Board of Zoning Appeals Meeting

MEETING DATE:	November 3, 2026
PROJECT:	41 Lawrence Street Healy Porch Enclosure Variance Request
APPLICANT:	James F. Wubbena, Wubbena Architects
PROJECT NUMBER:	ZONE-09-26-020478
PROJECT MANAGER:	Dan Frazier, AICP Planning Manager Department of Growth Management

REQUEST: The Applicant, James F. Wubbena of Wubbena Architects, requests a variance from the Unified Development Ordinance (UDO) Section 5.15.5.C to allow a 5.35-foot encroachment into the 10-foot setback along Dubois Lane for the enclosure of the existing screened-in porch (Attachment 1).

X24 P
5.35
104.68'
22.0'
6.5'
3.37
11 LAOK
11 LAOK
47

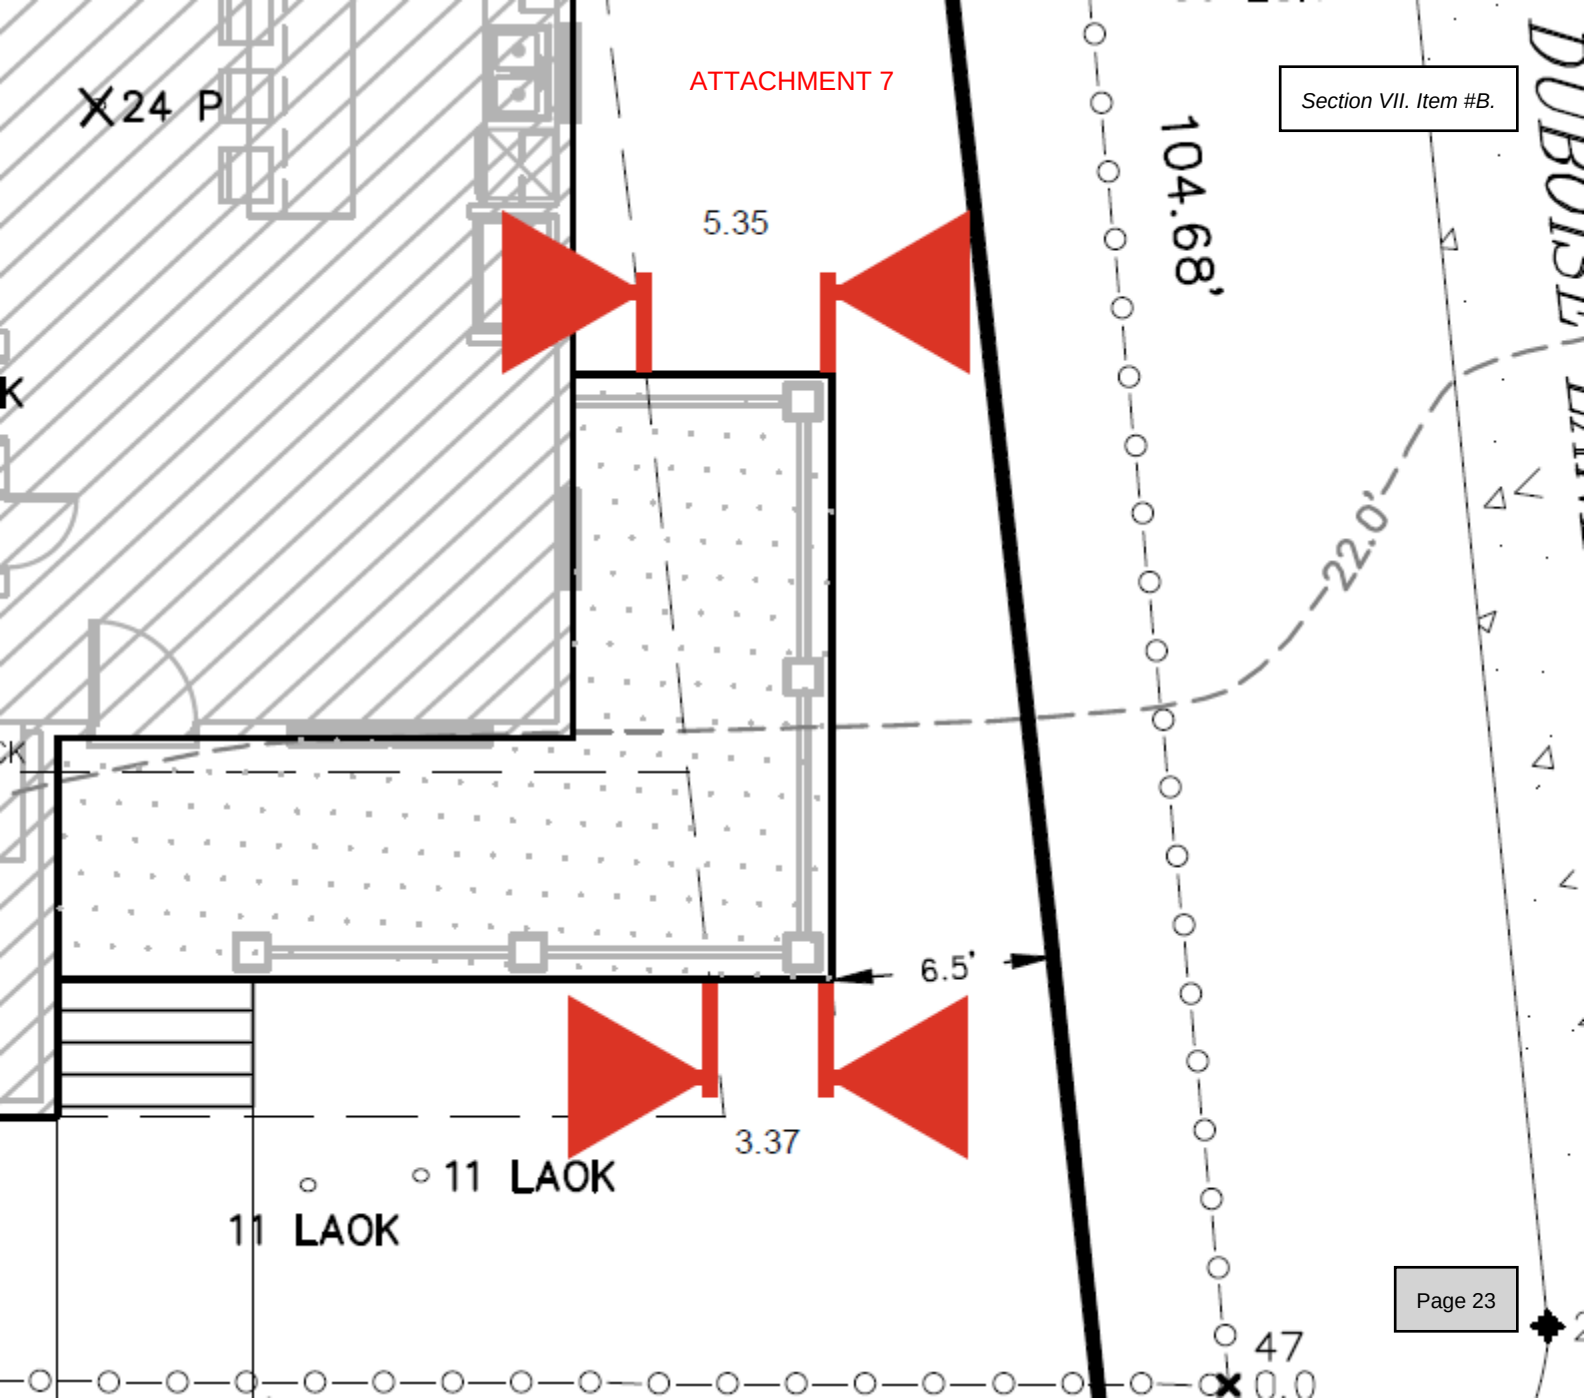
Finding. The property is a corner lot with frontage on Lawrence Street and Dubois Lane, and the proposed enclosure includes portions of an existing porch located within the required setbacks. The submittal does not demonstrate how these physical conditions constitute extraordinary and exceptional circumstances requiring the enclosure. The owner's medical documentation supports the need for first-floor office space but does not establish an exceptional condition pertaining to the particular piece of property. Staff finds that this criterion has not been demonstrated.

Finding. The application identifies the owner's medical needs as the basis for the request but does not establish that the property's physical constraints differ from those generally applicable to other properties in the vicinity or zoning district. The corner lot configuration and existing porch location, without further supporting information, do not demonstrate that distinction. Staff finds that this criterion has not been demonstrated.

Finding. The property is developed with an existing residence, and the setback requirements do not prevent its continued residential use. The submittal does not demonstrate that physical conditions of the property prohibit or unreasonably restrict its utilization consistent with other properties in the district. The application also does not establish whether other first-floor configurations or compliant alternatives were evaluated. Staff finds that this criterion has not been demonstrated.

GROUND FLOOR PLAN

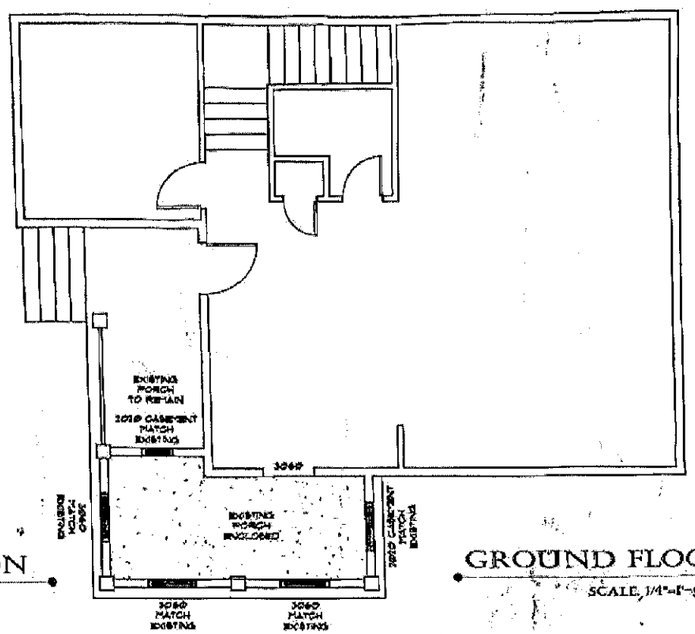
Finding. The request concerns enclosure of an existing covered porch rather than an expansion of its footprint. It is the Applicant's stated need for a first-floor office that is the basis for the variance request. As previously stated, the application does not establish whether other first-floor configurations or compliant alternatives were evaluated. Staff finds that this criterion has not been demonstrated.

Finding. The enclosure would occupy the existing porch footprint and retain the roof, with new windows and materials proposed to match the residence. These features may limit potential impacts on surrounding properties and district character. Nevertheless, enclosing the porch would change its appearance along both street frontages and remains subject to applicable Historic District design review. The absence of a footprint expansion alone does not establish that there would be no adverse impact.
